32ND AVENUE
(BETWEEN N. IRVINGTON ST. TO TAH PARKWAY)
AT THE AURORA HIGHLANDS
SITE PLAN

32ND AVENUE AT THE AURORA HIGHLANDS SITE PLAN

COVER SHEET

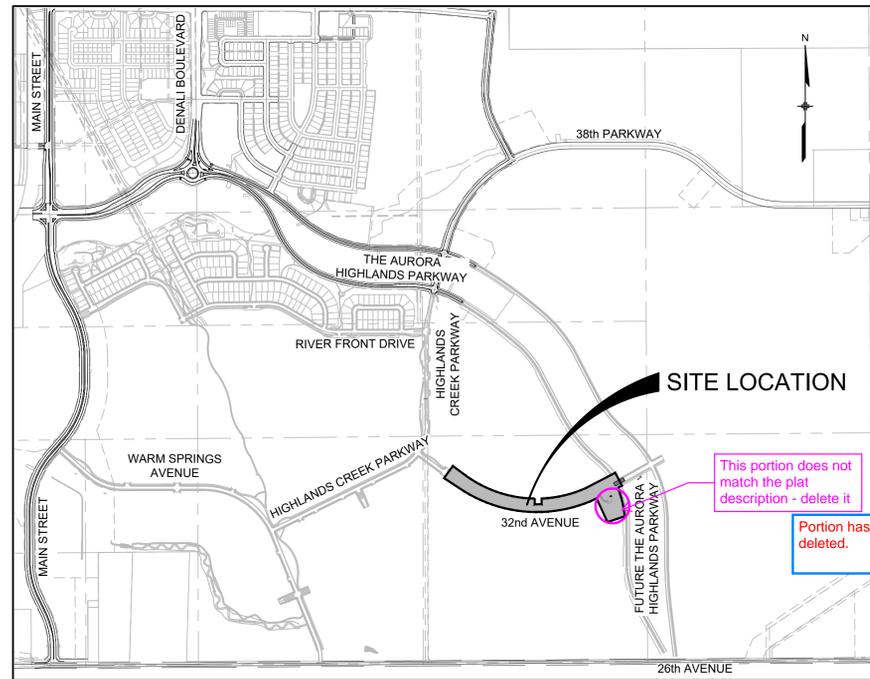
This portion does not match the plat description - delete it

Descriptions have been adjusted to match plat.

Portion has been deleted.

SITE PLAN

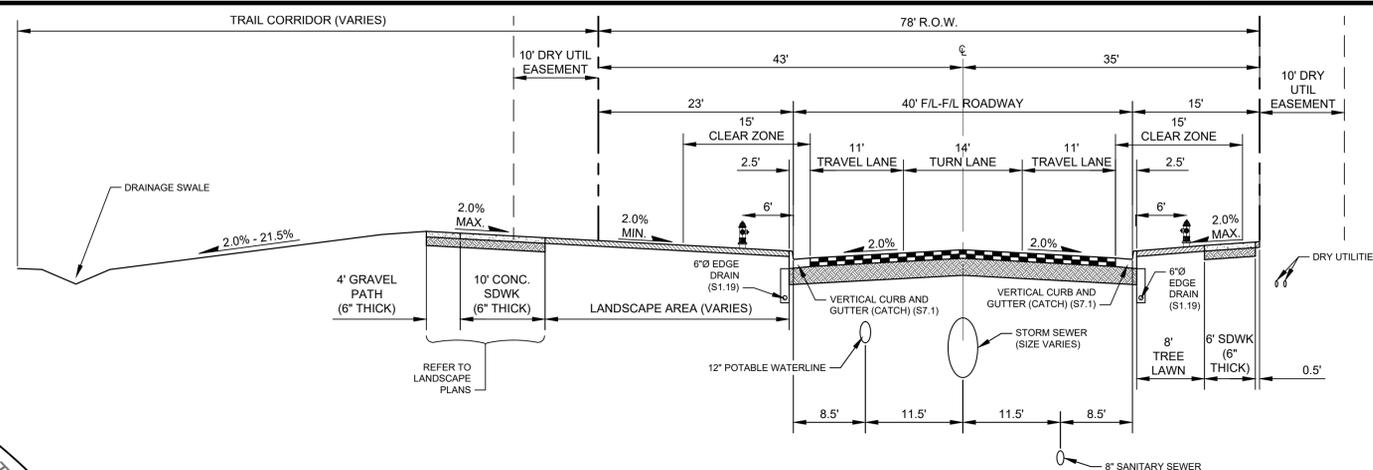
add the sidewalk easement shown on the Plat  
Added

Add Left Turn Arrow  
Corrected.

Relocate arrow to start of lane  
Corrected.

does crusher fines path need to be in the sidewalk easement too?  
Yes, easement on Site Plan and Plat has been revised to include crusher fines.  
Corrected.

Is this the street light? Fix leader  
Corrected.

Relocate arrow to start of lane  
Corrected.

Relocate arrow to start of lane  
Corrected.

Relocate arrow to start of turn lane  
Corrected.

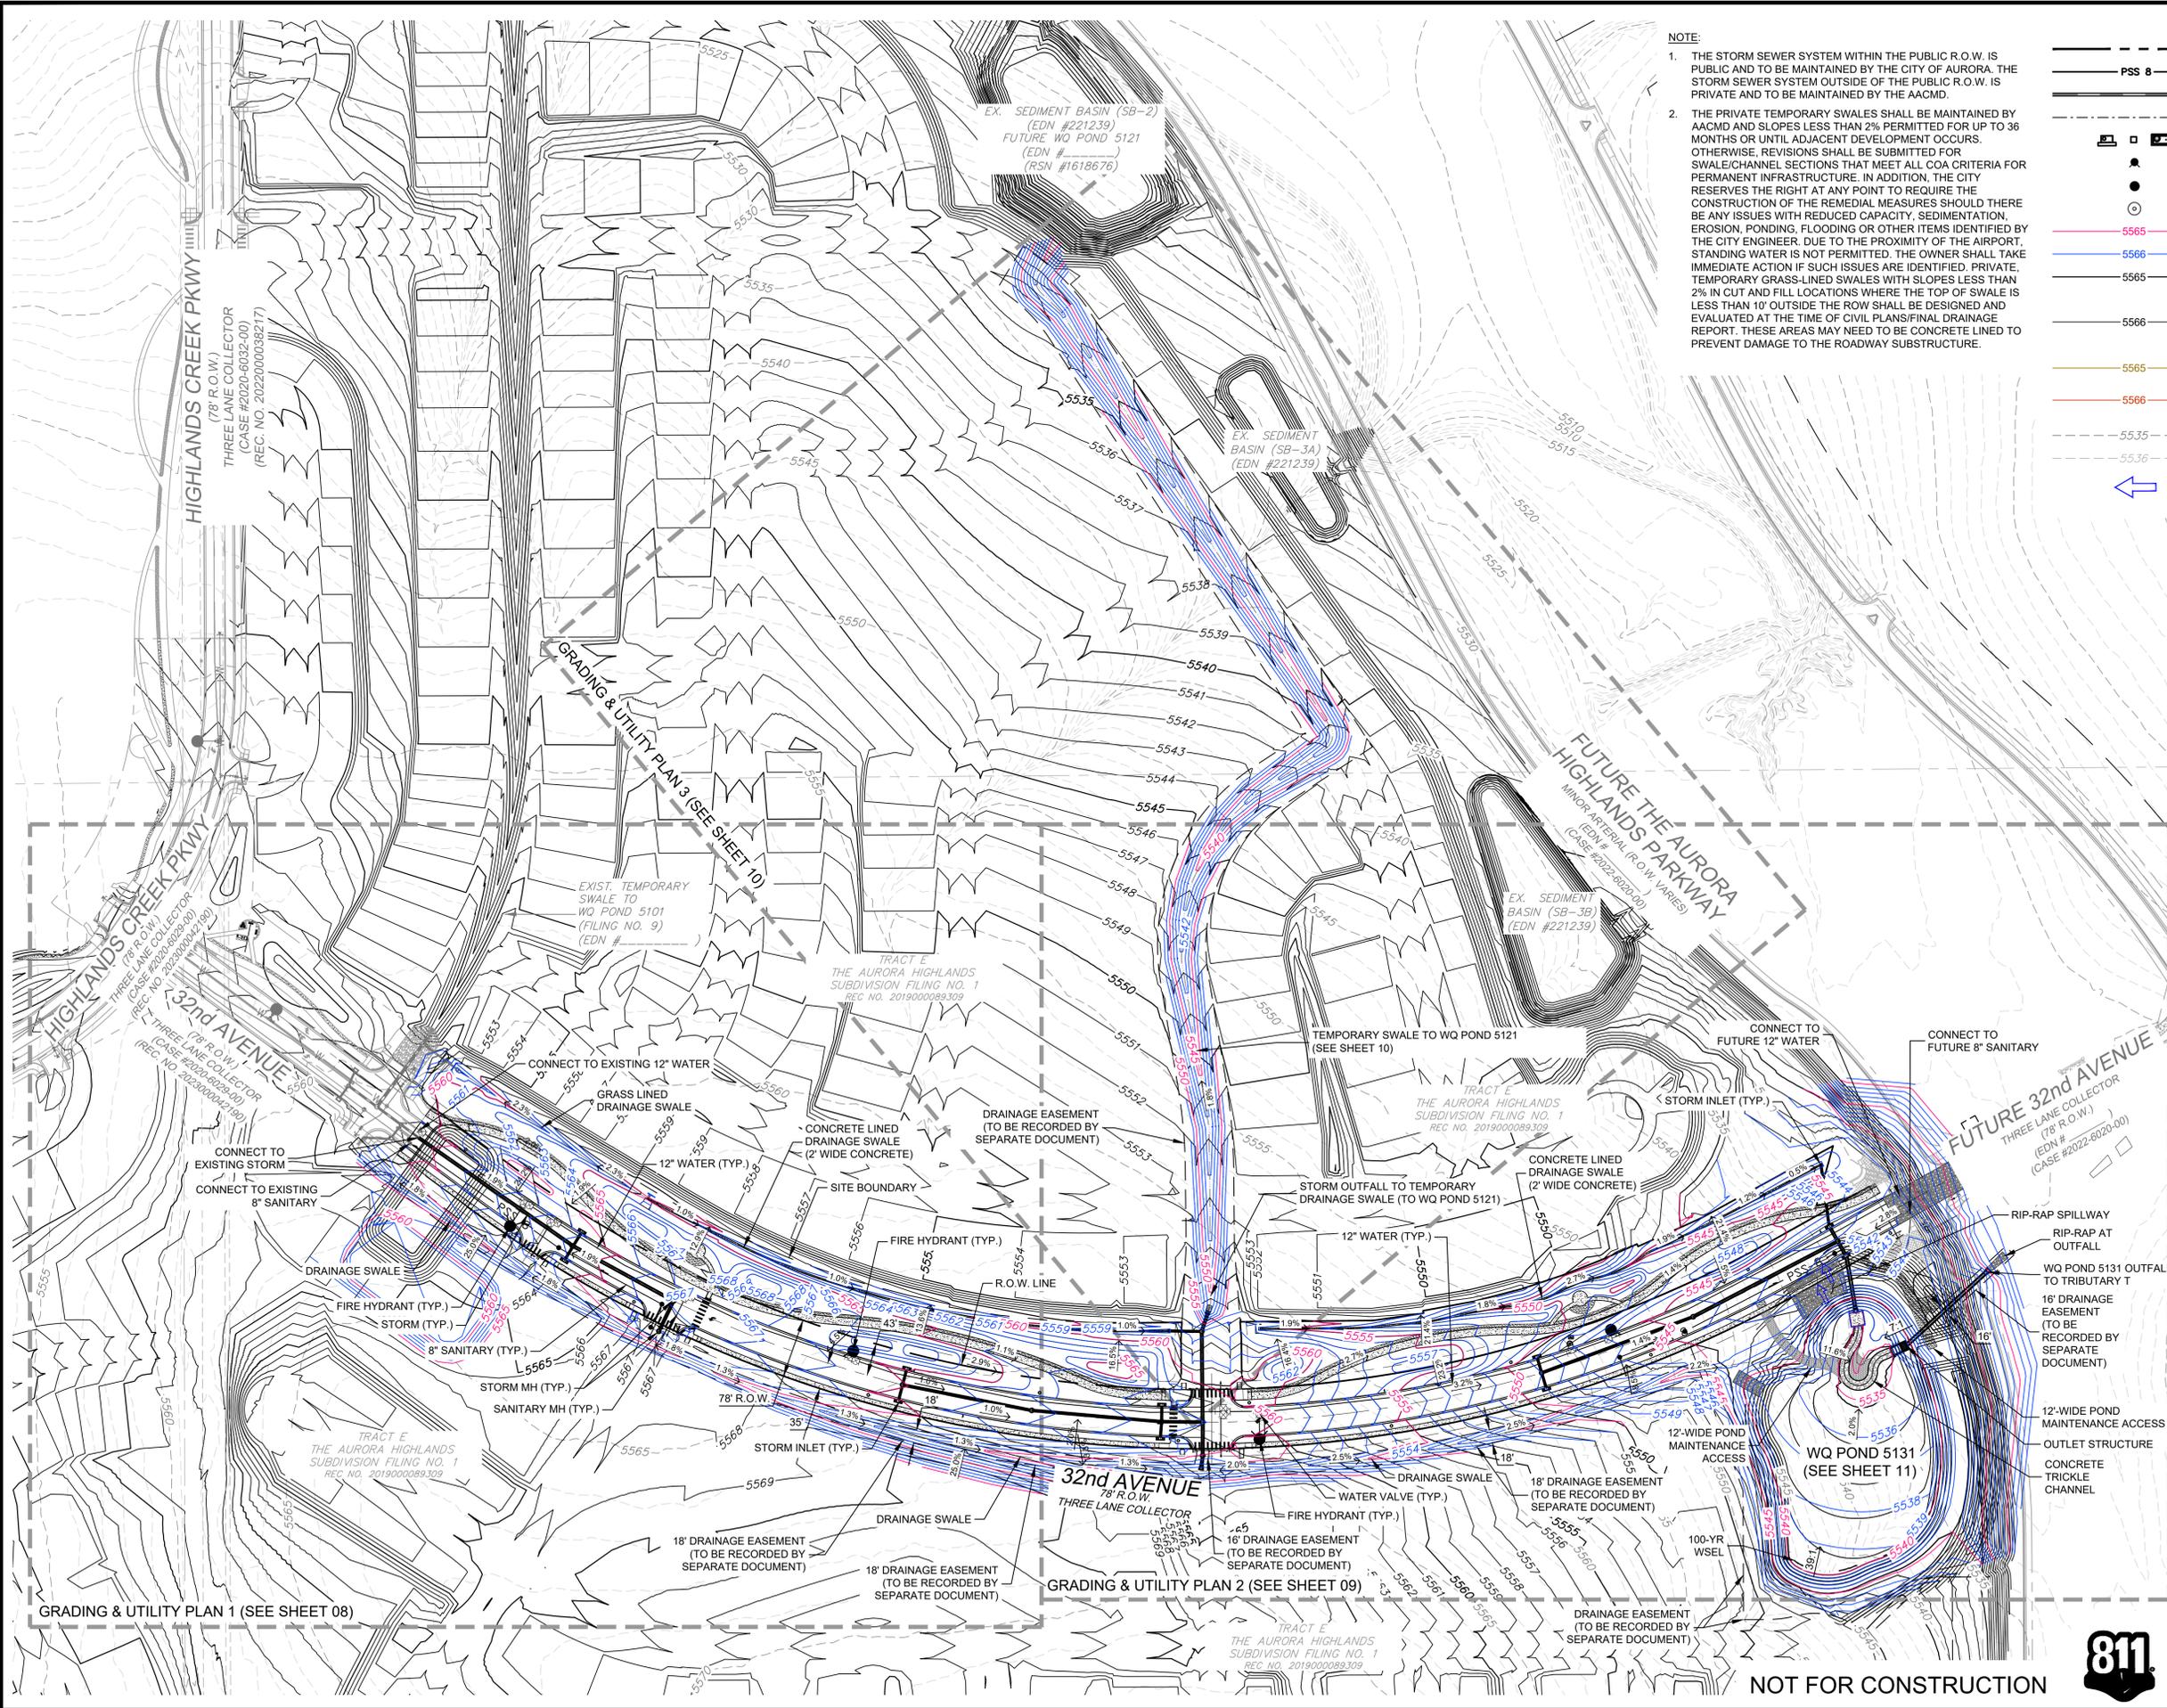
match plat = 1.39 ac  
Corrected.

right-of-way linework  
should match legend  
Corrected.

Is this the street  
light? Revise leader  
Corrected.

32ND AVENUE  
AT THE AURORA HIGHLANDS  
SITE PLAN  
GRADING & UTILITY PLAN

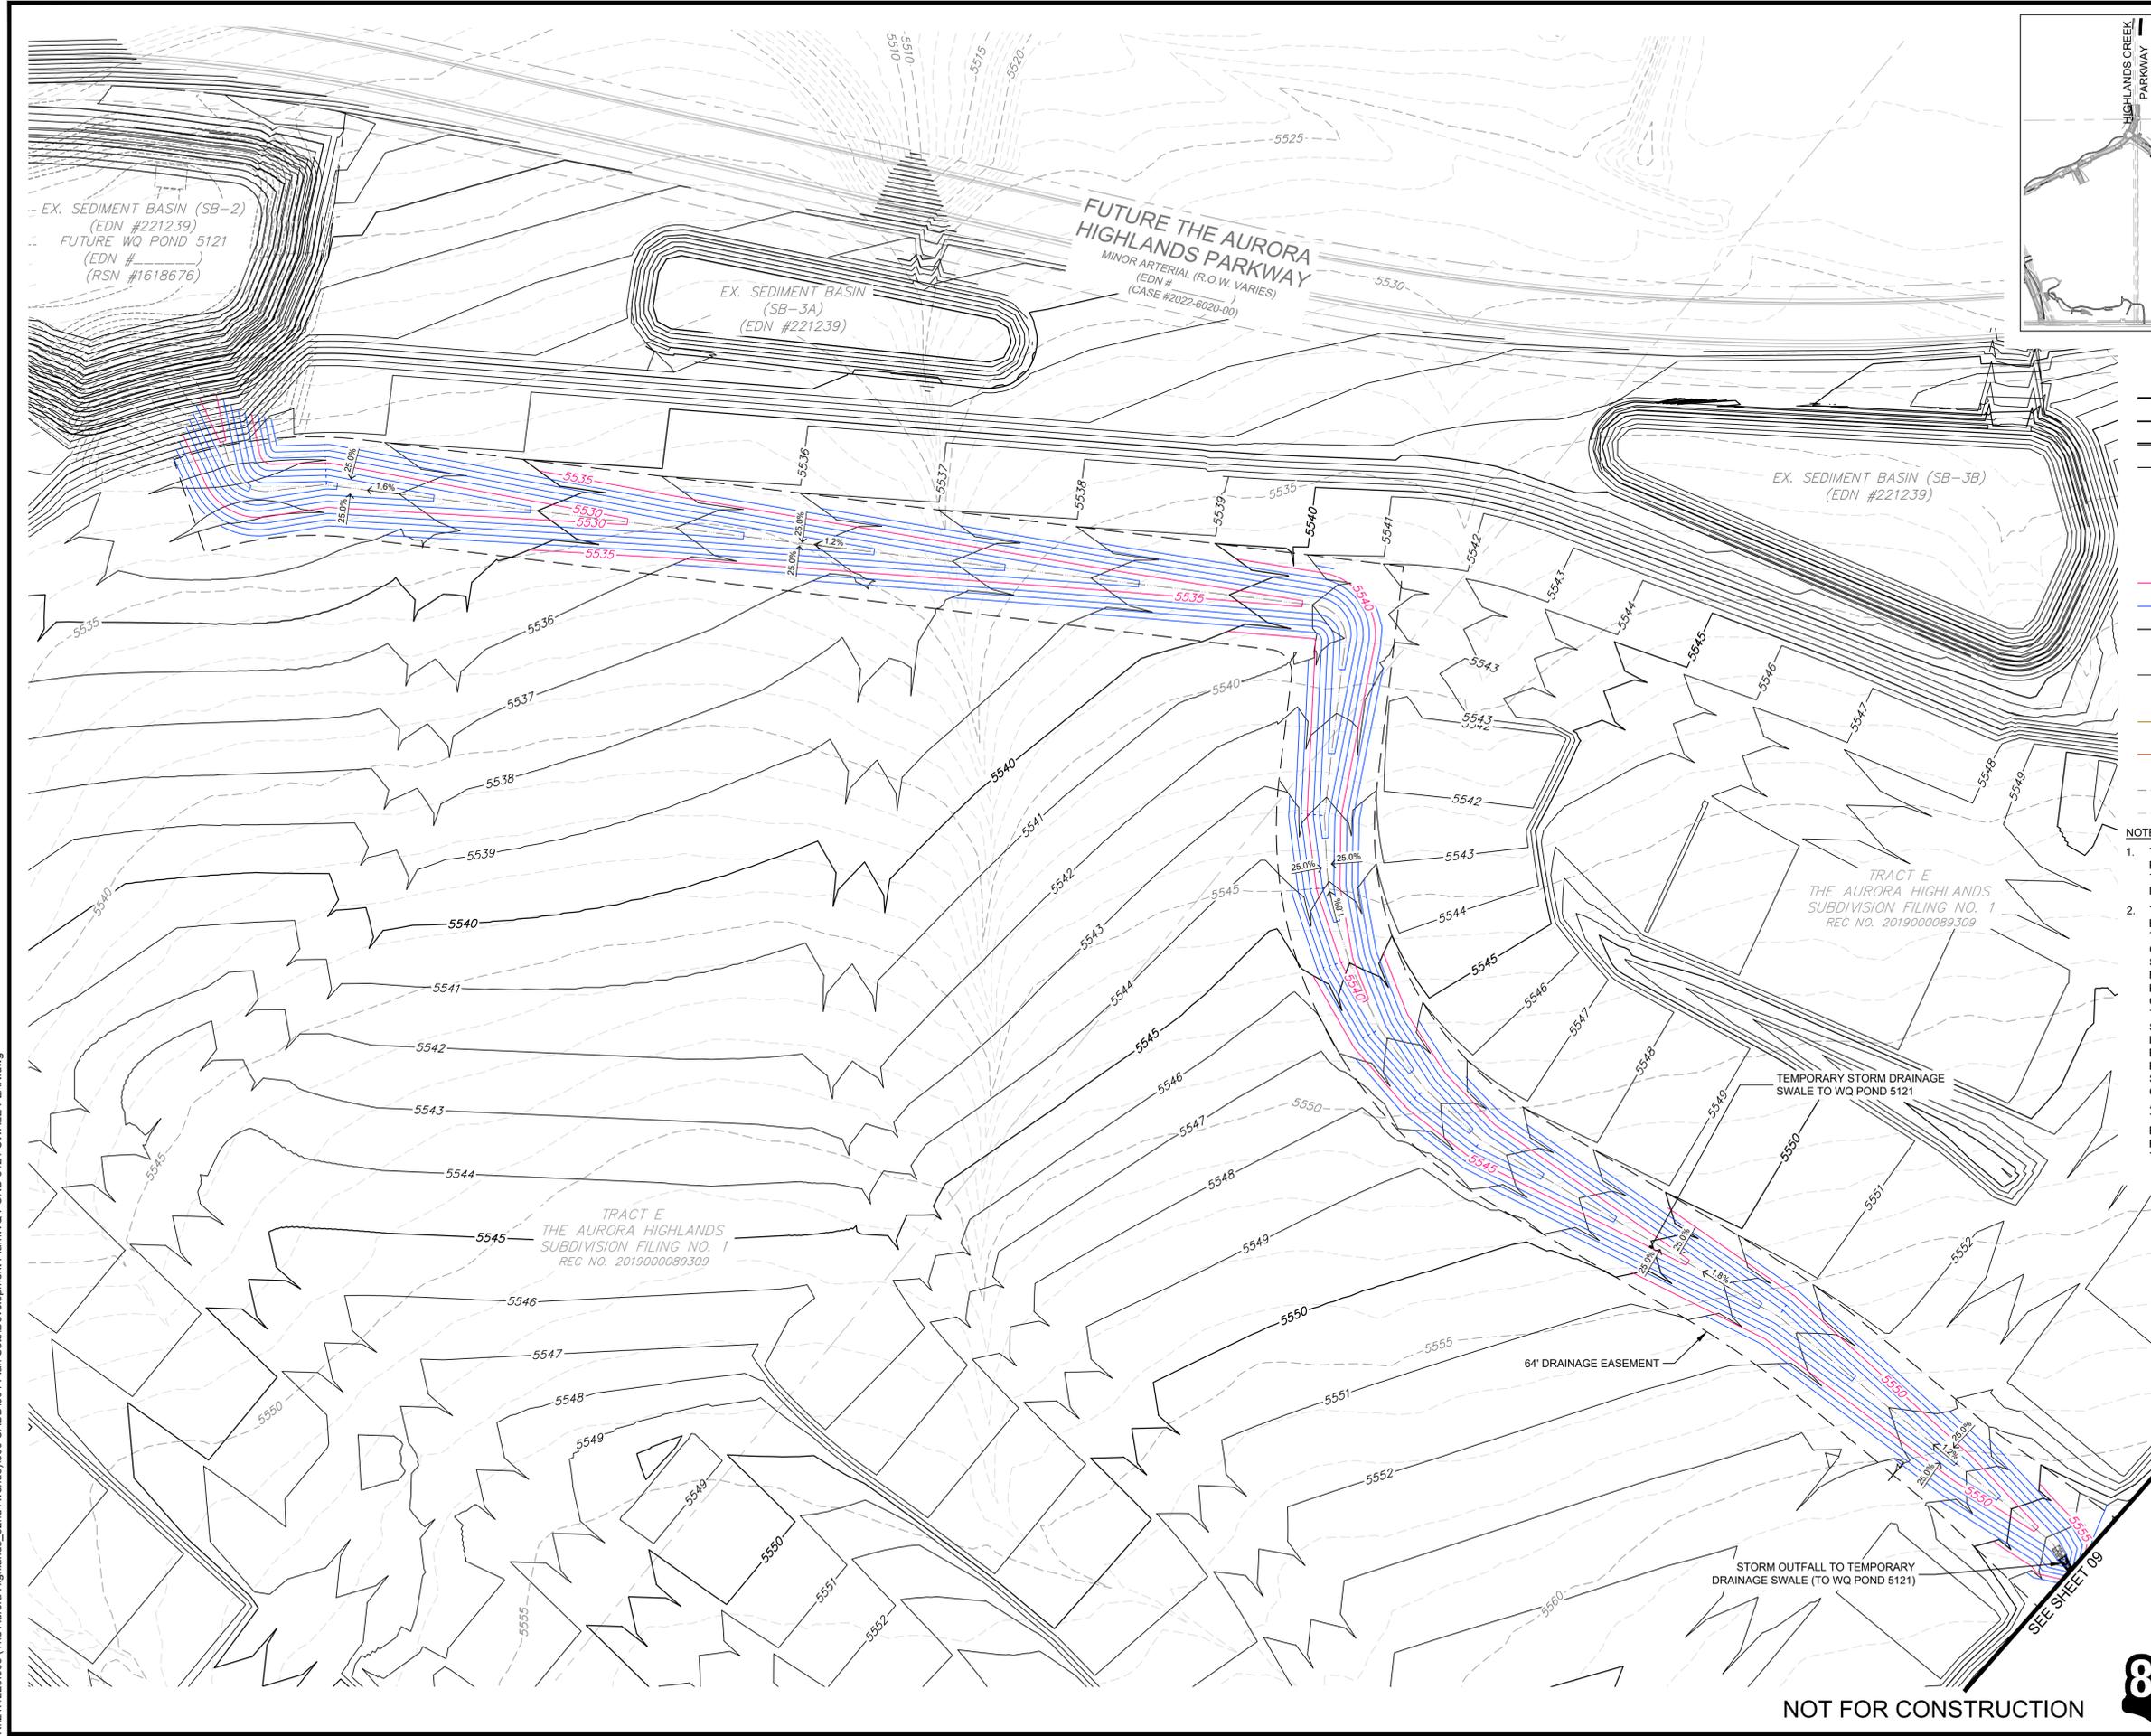
do the color contours represent 'ultimate' condition? If so, has the area been graded per the EDN? is that actually the existing grade?

clarify because these are overlapping.

what is proposed?

Tan and orange contours have been removed. Color contours represent the ultimate conditions after completion of this project. Gray contours for 'existing' are used to distinguish the surface prior to any construction projects in the area while the dark contours for EDN 221239 are being used to show how the surface will exist at the start of construction for this project. We are showing both the existing and EDN 221239 contours as grading in this project will tie to each of these at different locations.

L2.01 - LANDSCAPE PLAN  
SHEET: 15 OF 22

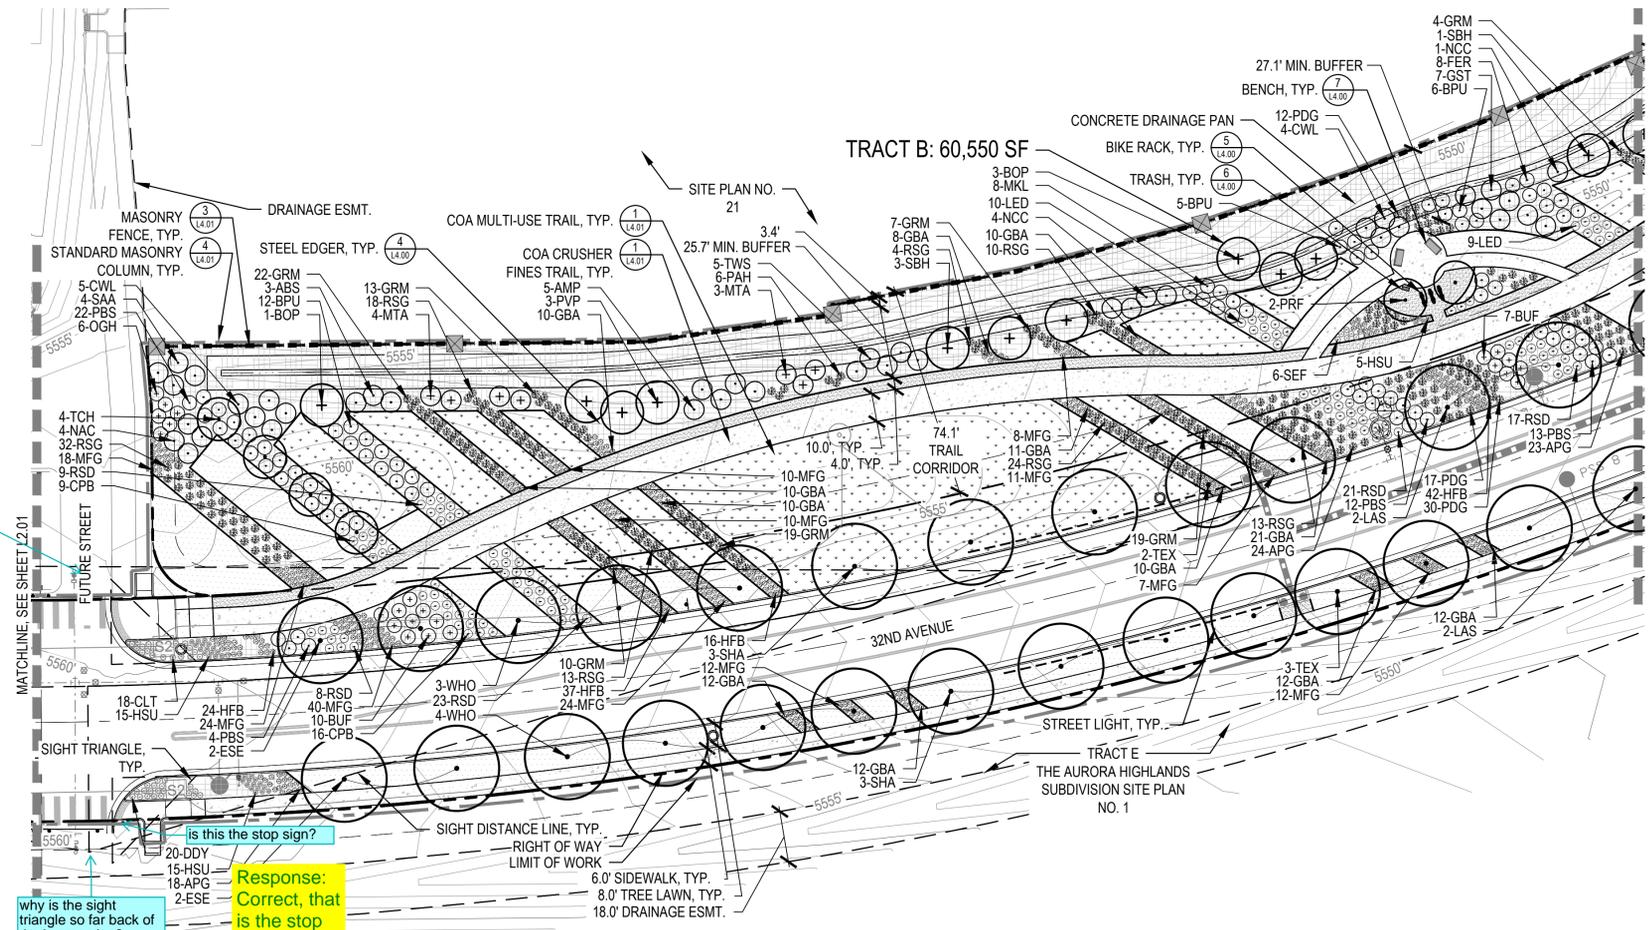
this street has been named

Response: Street name has been updated.

Response: Correct, that is the stop sign.

Response: Sight triangles have been confirmed with civil
